Subject: Site Assessment and Pilot Test Workplan Addendum
Shore Acres Gas
403 East 12th Street, Oakland, Alameda County, California
RO #0002931
ECG # GHA.19009

Subject: *Workplan Addendum to the Site Assessment and Soil Vapor Extraction Pilot Test Workplan* dated February 9, 2011 for Fuel leak Case No. RO0002931, Shore Acres Gas, 403 12th Street, Oakland, California

Subject: Work Plan Denial for Fuel Leak Case No. RO0002931 and GeoTracker Global ID T0600174667, Shore Acres Gas, 403 E 12th St., Oakland, CA 94606

FIGURE 3

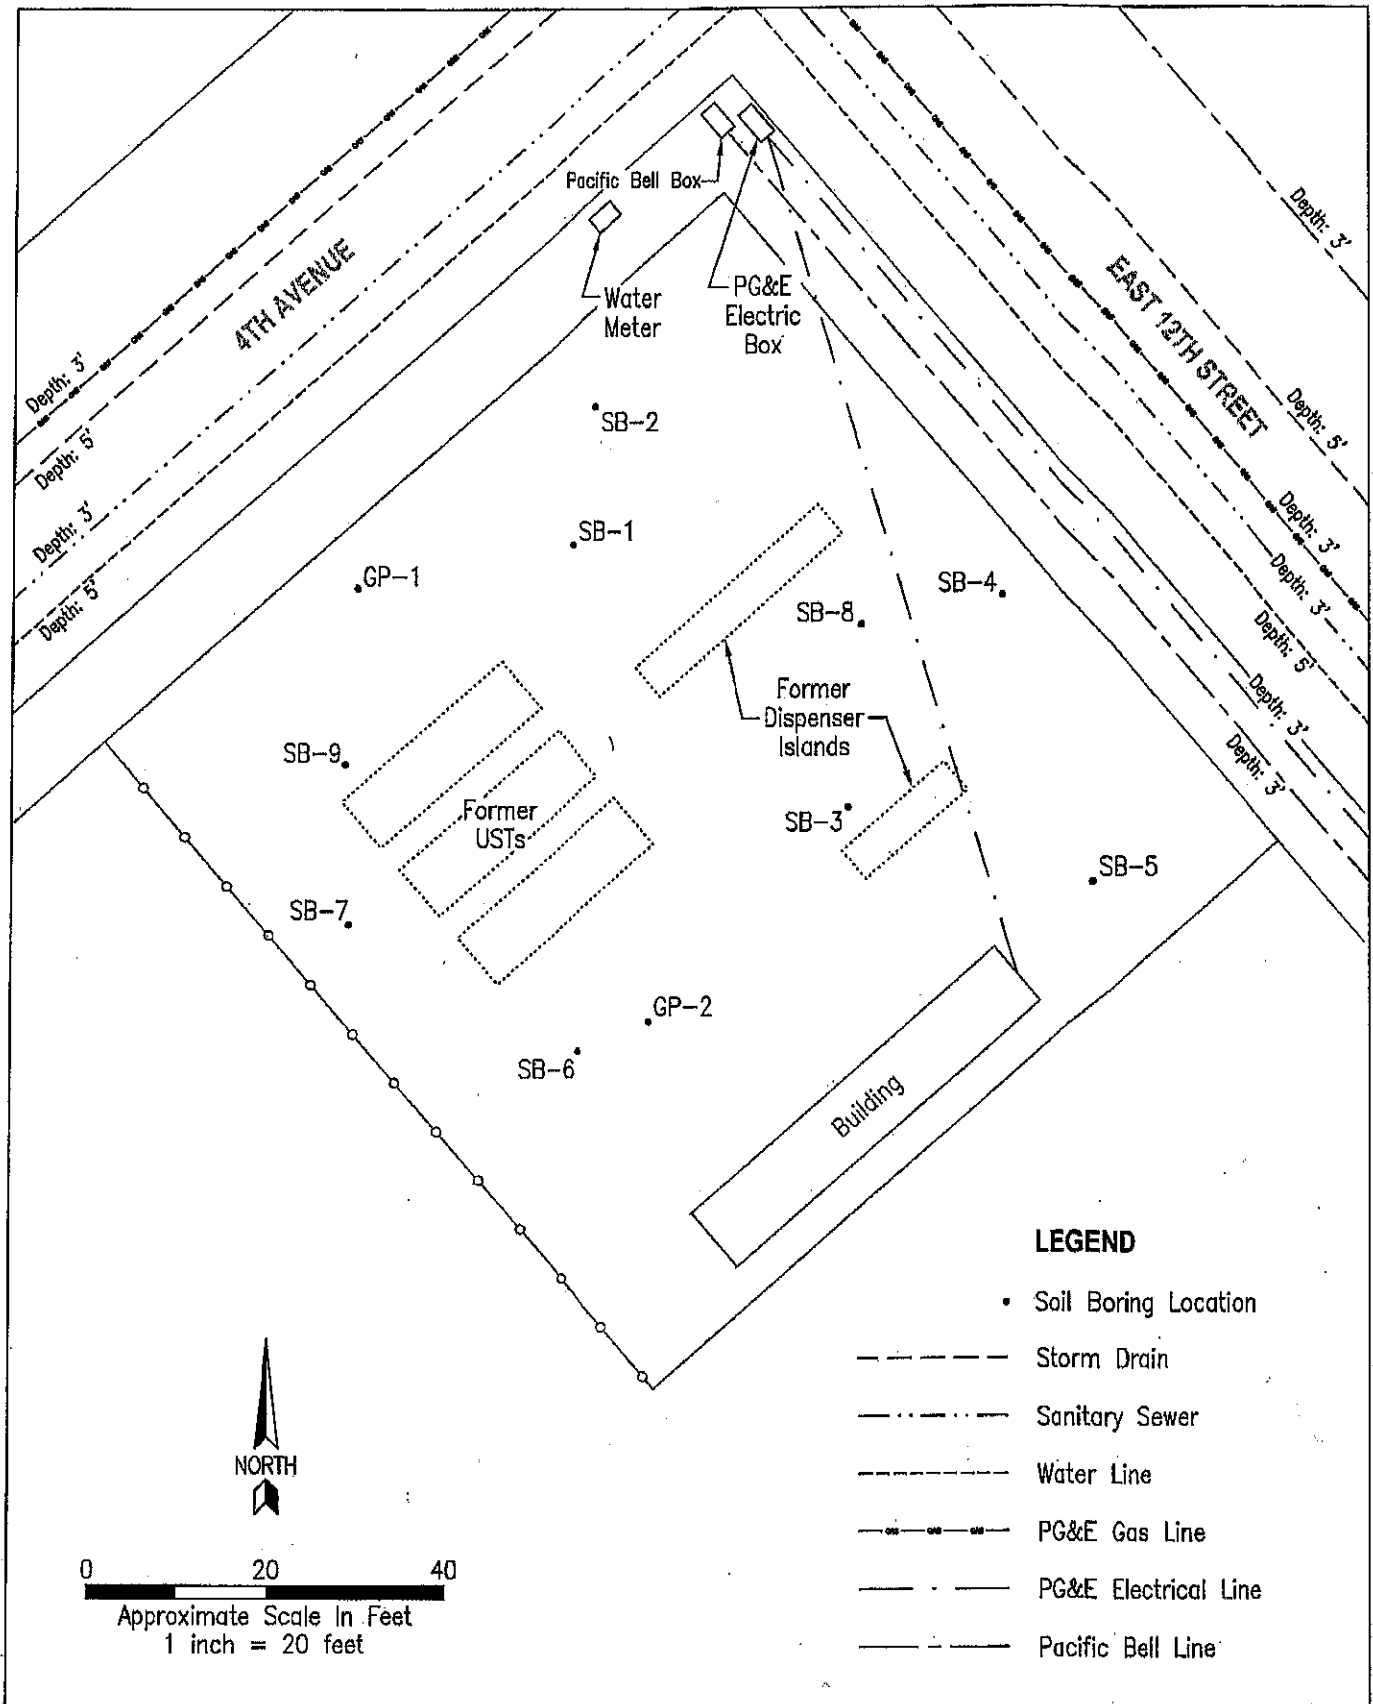
3. **Preferential Pathway Study** – Please include the depths of the utilities on your preferential pathway study map. Also, please place these conduits on an expanded site plan showing areas off site as well. The proposed offsite borings should be placed on this extended site plan which should be included in the work plan addendum requested below.

A revised preferential pathway with utility depths is included as Figure 3 and a downgradient preferential pathway and proposed soil boring location map is included as Figure 8. The underground utilities listed in the Workplan were extended to include the utility drawings listed in the *Phase I Environmental Site Assessment* for the Downtown Educational Complex prepared by Ninyo and Moore Geotechnical and Environmental Sciences Consultants located down gradient of the site.

All subsurface utilities found were very shallow, less than 5-feet bgs, and are unlikely groundwater conduits based on their depths. However, on the Figure 8, the downgradient preferential pathway map, a proposed soil boring (SB-10) has been included to address the potential for offsite migration along potential conduits along the south side of 4th Avenue. Soil samples and a grab groundwater sample will be analyzed for the constituents outlined in ECG's Workplan Report.

FIGURE 5

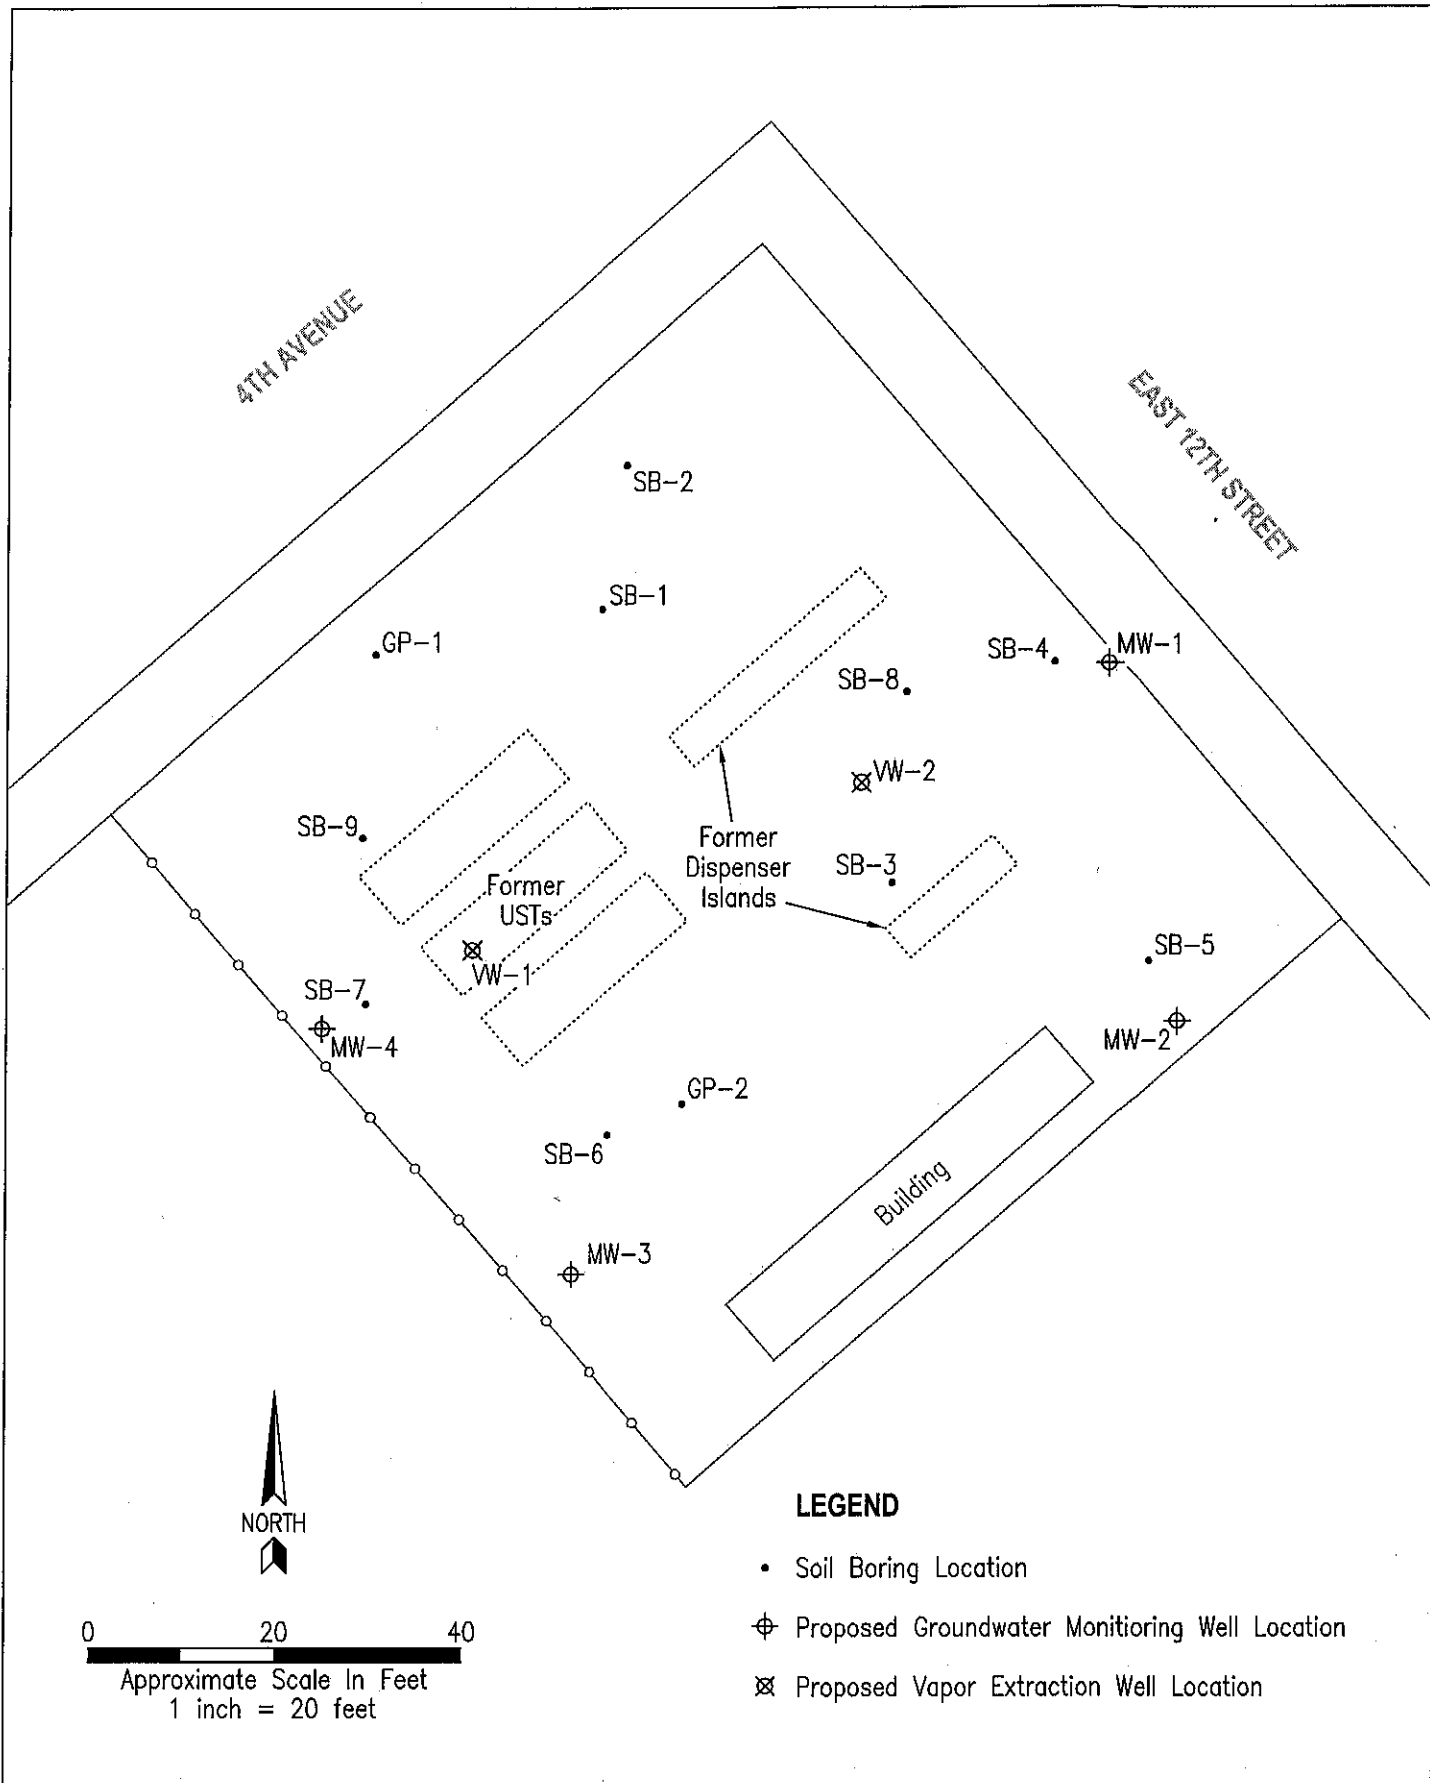
The proposed soil vapor extraction well screen intervals may intercept groundwater based on recent depths of groundwater in the vicinity. No discussion of how water will be treated is included in the pilot test workplan. No observation wells for the soil vapor pilot test were proposed to determine the radius of influence for the test. Please adjust your plan to provide details of the test including well screen intervals, observation wells, procedures for handling groundwater, standard operating procedures, etc.

The two new extraction wells (VW-1 and VW-2) will be used as extraction points during the test. The new extraction wells will be individually tested. The well locations are shown on Figure 5. It is anticipated that DPE tests will be conducted on wells VW-1 and VW-2, if water is present.

FIGURE 6

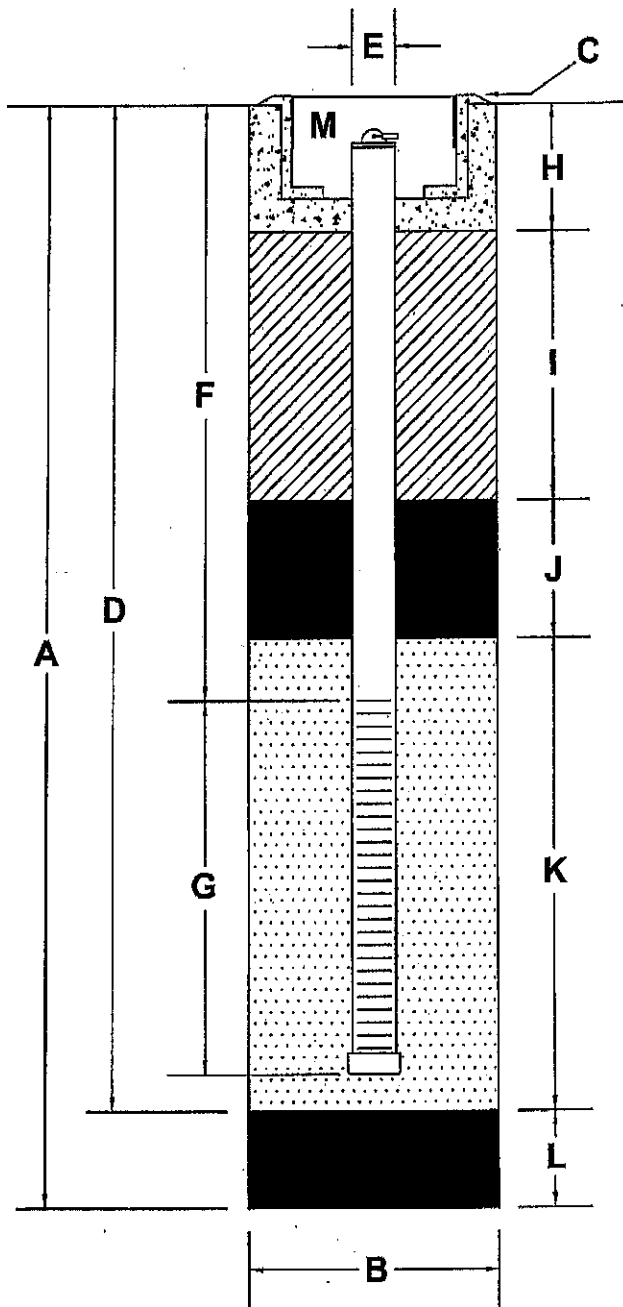
1. **Regional Geologic and Hydrogeologic Setting** – Groundwater at a nearby site (RO2853) located at 506 International Blvd., ranges from 7 feet below ground surface (bgs) to 12 feet bgs, while the depths to water at nearby sites that you identified were even shallower. Based on these depths the screened intervals for the proposed wells appear to be too deep. In addition, the screen length is too long. We agree that you should advance the boring and leave it open to see what water level enters the boring but since we recommend shallower screen intervals at a maximum of 10 foot length that straddle the water table, we recommend advancing one boring to 10 feet and another to 15 feet and waiting for water to enter the borings. Please modify the screened intervals in the workplan addendum requested below.

ECG will install two borings the first day of drilling, with one boring to 10 feet and another boring to 15 feet bgs and wait overnight for groundwater levels, if encountered, to equilibrate. These groundwater elevation measurements will be used to construct groundwater monitoring wells with 10-foot long screened intervals that straddle current groundwater elevations. A revised proposed monitoring well construction diagram is shown on Figure 6 with actual field construction specifications could be adjusted based on field conditions. Vapor extraction wells will be installed as potential dual phase wells with several feet of well screen below the water table.

FIGURE 8
 Project Number:
 GHA.19009
 Date:
 April 14, 2011

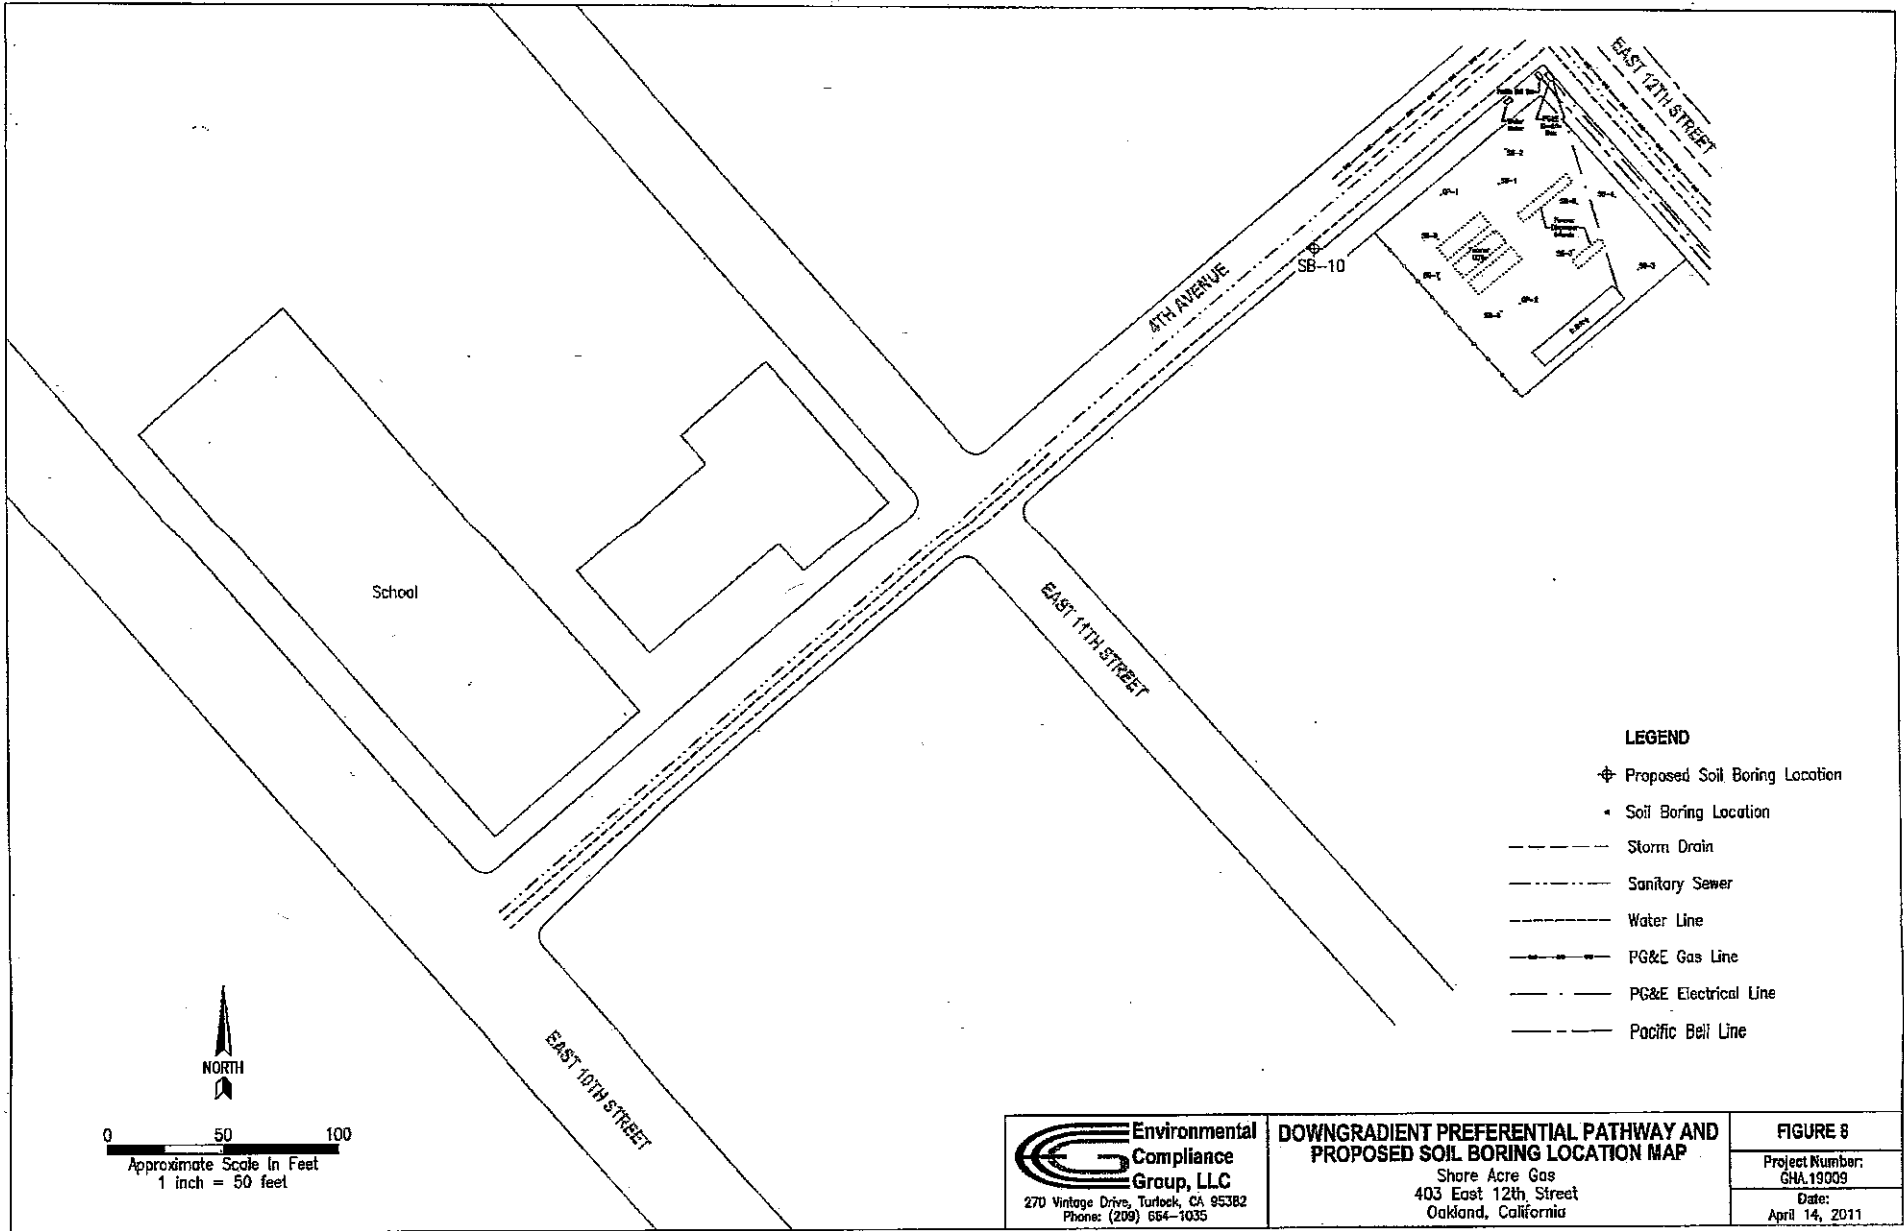
2. **Soil and Groundwater Characterization** – In our December 16, 2010 directive letter, ACEH requested an off-site investigation that evaluates contamination that may be moving onto the school property from your site. Further, MTBE contamination appearing to originate from your site has been, has been detected at the school across the street. Please include in your proposed boring locations in the work plan addendum requested below.
